UNITED STATES PATENT AND TRADEMARK OFFICE

| 10/594,592 | 09/28/2006 | Pierluigi Oresti | 296853US6X PCT | 5570 |

| Office Action Summary | Application No. 10/594,592 | Applicant(s) ORESTI ET AL. | |

DETAILED ACTION

4,778,443

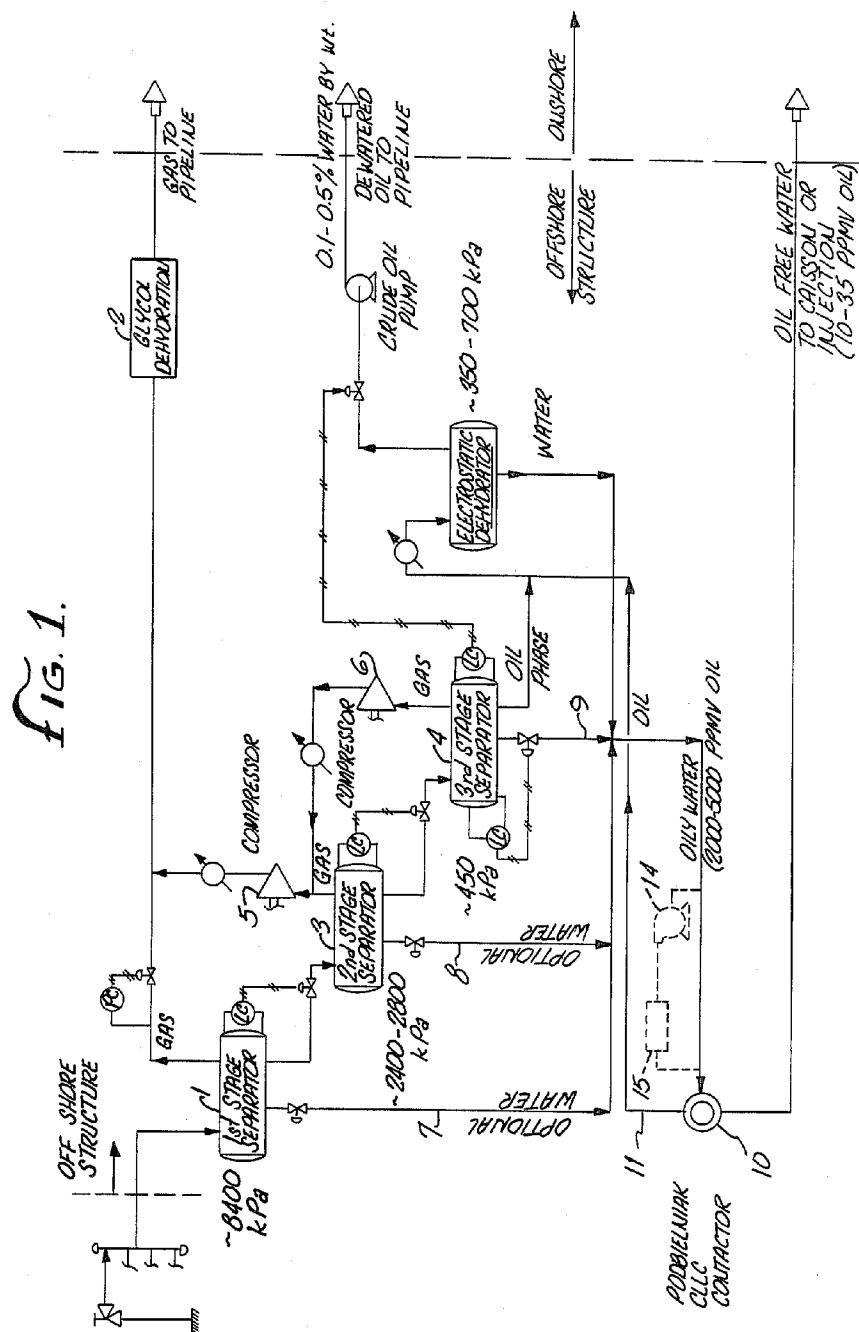
For instant **claims 15-19**, SANDS et al. teaches at the abstract, column 6 lines 1-40, figure 1 and claim 1 delivering the gas/oil/water (fluid) from the offshore facility (field) to a high pressure gas/liquids separation stage.

Also for instant **claims 15-19**, SANDS et al. teaches at the abstract, column 6 lines 1-40, figure 1 and claim 1 where the gas/oil/water (fluid) is split into a gas phase substantially consisting of petroleum gases (light hydrocarbon).

Additionally for instant **claims 15-19**, SANDS et al. teaches at the abstract, column 3 lines 50-68, column 4 lines 34-45, column 6 lines 1-40, figure 1 and claim 1, oil/water (two liquid phases) one of which mainly consists of water, the other substantially of oil (hydrocarbon liquids).

been separated in the medium-pressure and low-pressure (decreasing pressure) separation stages to corresponding compression units (5 and 6) to recompress the gases.

As well for instant **claims 15-19**, SANDS et al. teaches at the abstract, column 3 lines 50-68, column 4 lines 34-45, column 6 lines 1-40, figure 1 and claim 1 using compressors (5 and 6) to compress gases, except SANDS et al. does not specifically teach **(1)** the ejector type of compressor, and **(2)** the compressed gas exiting from the last (one of) compression stages of the reinjection gas compression unit as the driving fluid of each single ejector. It would have been obvious to one having ordinary skill in the art at the time the invention was made to **(1)** use ejectors as the type of compressor, since LAGRONE teaches at column 1 lines 5-30 that such a modification would improve the suction capabilities of a fluid delivery system over other similar pumps (compressors).

For instant **claim 25**, SANDS et al. teaches at the abstract, column 3 lines 50-68, column 4 lines 34-45, column 6 lines 1-40, figure 1 and claim 1 wherein the recompressed gases exiting from the compression units (5 and 6) are used as petroleum gas to a pipeline (fuel gases).

WO 00/11313

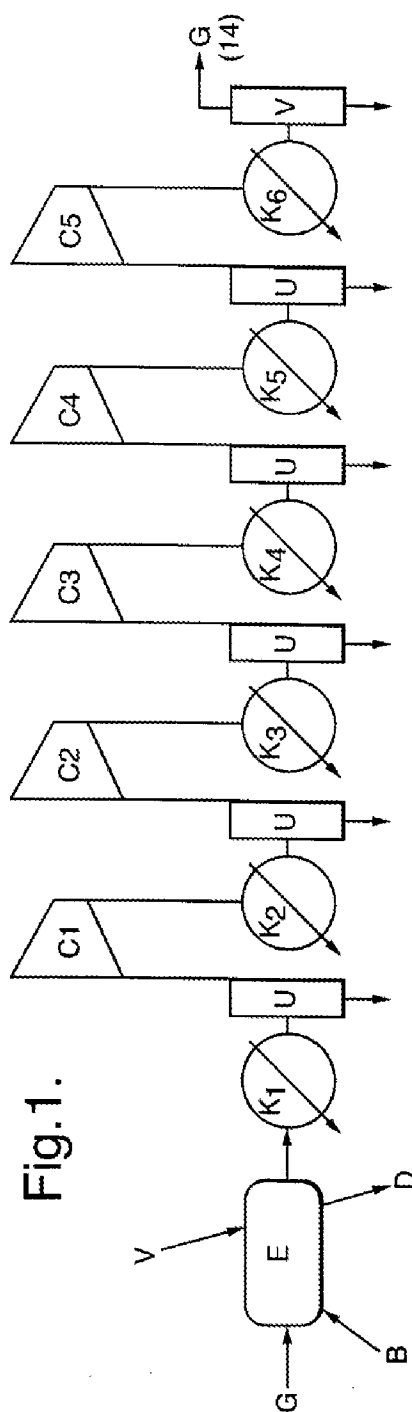
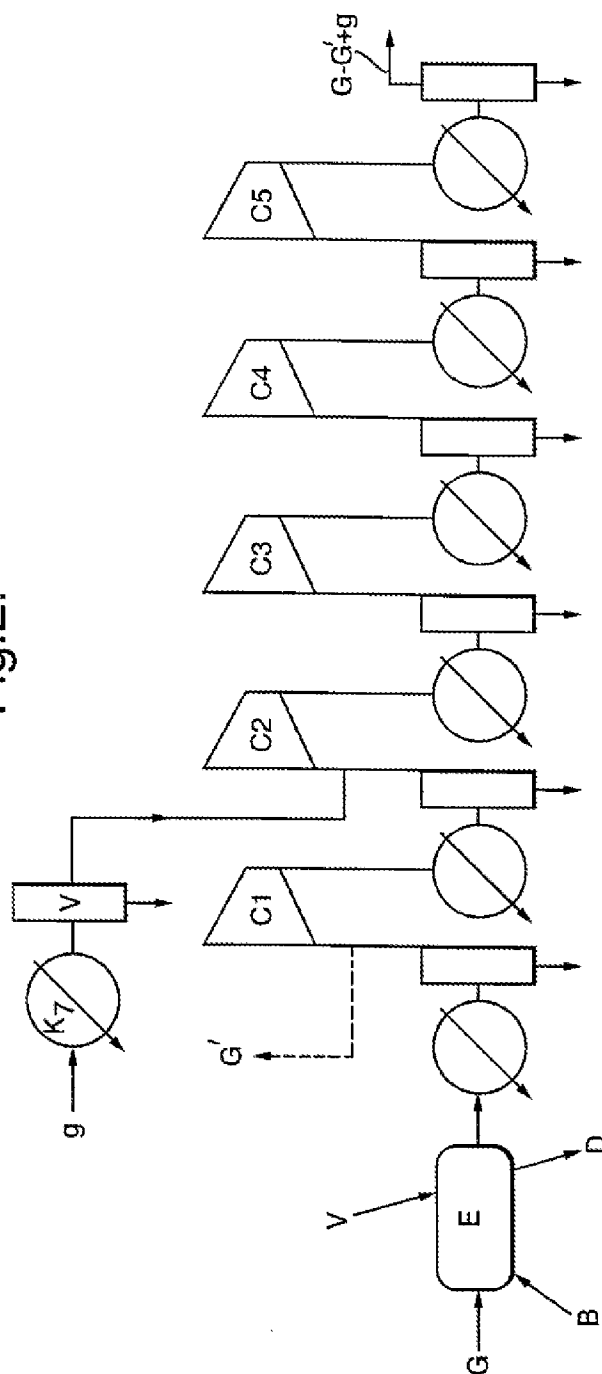
In addition for instant **claims 15-19**, SANDS et al. does not teach delivering the light hydrocarbon gases, separated in the high pressure separation stage, to a reinjection gas compression unit having at least two compression stages. AAREBROT et al. teaches at page 1 lines 15-20, page 4 lines 1-30, figure 1, and figure 2 delivering oil associated gases (light hydrocarbon gases), to a reinjection gas compression unit having at least two compression stages (C_1 - C_5). It would have been obvious to one having ordinary skill in the art at the time the invention was made to process the petroleum (oil) gas of SANDS et al. with the reinjection system of AAREBROT et al., in order to retain the pressure of the reservoir in order to facilitate the oil recovery as taught by AAREBROT et al. at page 1 lines 15-20.

Also for instant **claims 15-19**, LAGRONE teaches the technique at column 1 lines 45-68, column 2 lines 15-50 and figure 1 **(2)** the compressed gas exiting from the last (one of) compression stages of the centrifugal pump (compression unit) as the fluid directed to (driving fluid) the ejector. AAREBROT et al. teaches at page 1 lines 15-20, page 4 lines 1-30, figure 1, figure 2 using a reinjection gas compression unit as discussed above for the obviousness to one of ordinary skill in the art of in order to retain the pressure of the reservoir in order to facilitate the oil recovery. Also, the (compression unit) taught by LAGRONE is similar to the

For instant **claim 23**, SANDS et al. does not teach wherein the reinjection gas compression unit includes three compression stages. But, AAREBROT et al. teaches at the abstract, page 1 lines 15-20, page 4 lines 1-30, page 2 lines 25-32, figure 1, and figure 2 wherein the reinjection gas compression unit includes

three compression stages (C_1 - C_3). It would have been obvious to one having ordinary skill in the art at the time the invention was made to process the petroleum (oil) gas of SANDS et al. with the reinjection system of AAREBROT et al., in order to retain the pressure of the reservoir in order to facilitate the oil recovery as taught by AAREBROT et al. at page 1 lines 15-20.

4,339,917

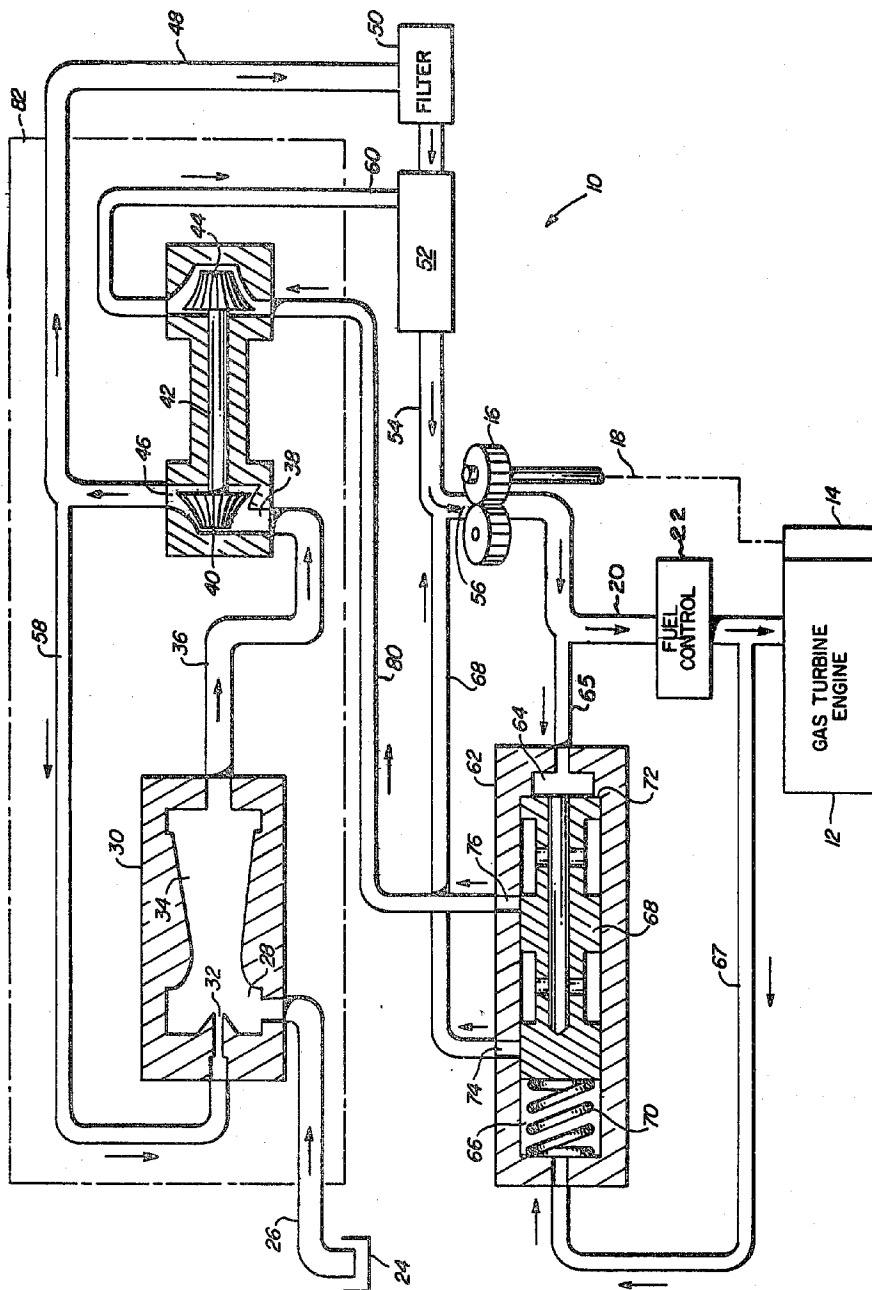
For instant **claims 21 and 22**, SANDS et al. does not teach wherein **(1)** the compressed gas to be used as driving fluid is taken below the compressor **(2)** before the cooling heat exchanger. But, LAGRONE teaches the technique at column 1 lines 45-68, column 2 lines 15-50 and figure 1 wherein the compressed gas to be used as directed fluid (driving fluid) is taken below the centrifugal pump (compressor). AAREBROT et al. teaches at page 1 lines 15-20, page 4 lines 1-30, figure 1, figure 2 using a reinjection gas compression unit as discussed
